FIELD OBSERVATION REPORT - Bldg #14

Permit No. 18-131555-00 DC
 Owner: Vinager Grand Centro Assn, Inc.
 Project Address: 4017 Crookers Lake Blvd., Sarasota, FL
 Contractor: RL James Inc.
 Inspector (s): Mark Boss / Mike James
 Type of Assessment: Progress

PROJECT NAME:
**WOOD FRAME REPAIRS & RELATED WORK (PHASE II)
VINTAGE GRANDE CONDOMINIUM ASSOCIATION, INC.
4012 CROCKERS LAKE BLVD., SARASOTA, FL 34238**

PHOTOGRAPH #11

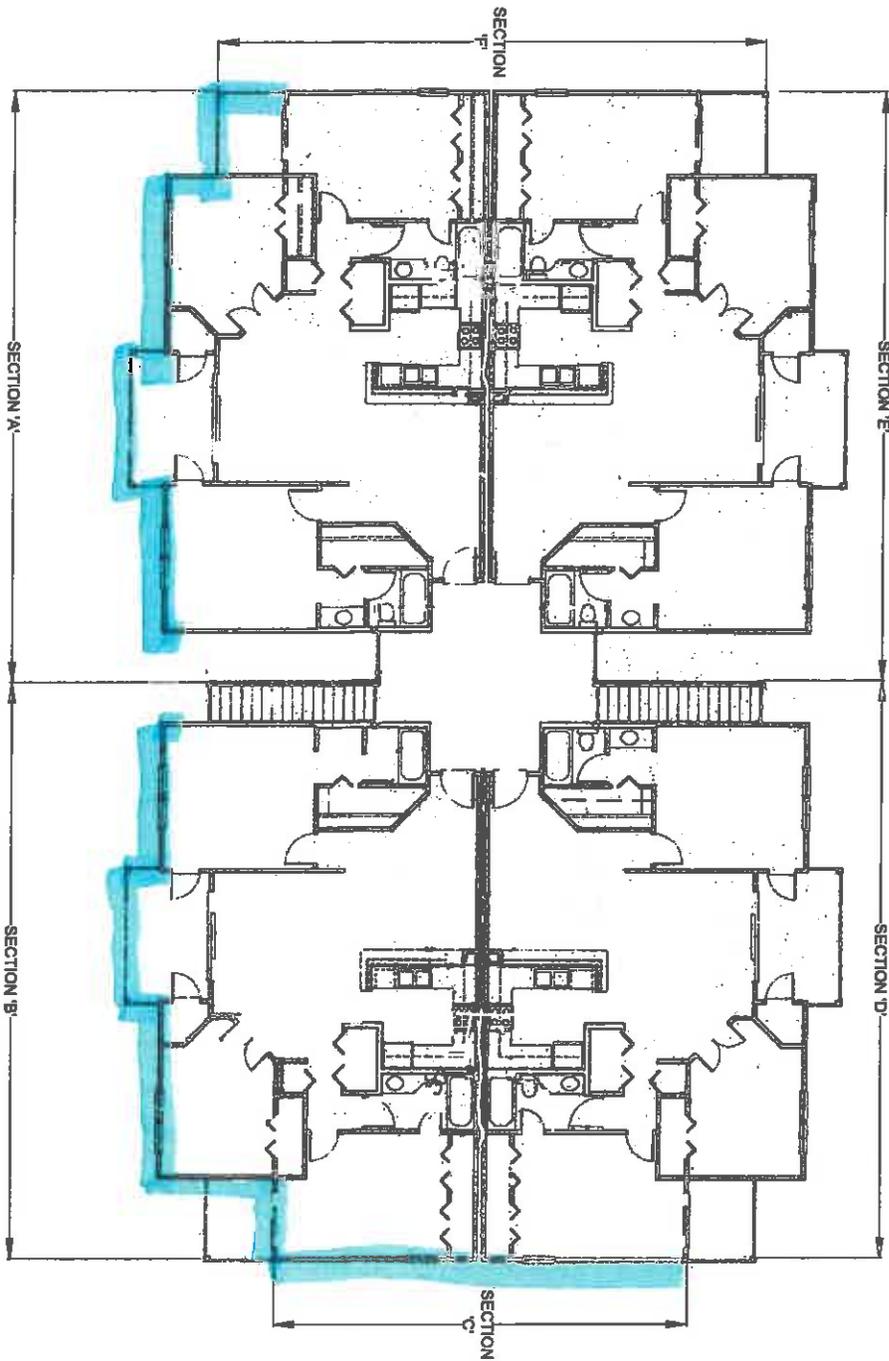
As defined by OSHA, scaffolding must be designed by qualified person. Erection, dismantling, moving or altering must be supervised by competent person. The access ladder is not correct or the rail in place at wallboards between platforms. Contractor will make corrections as per OSHA regulations.
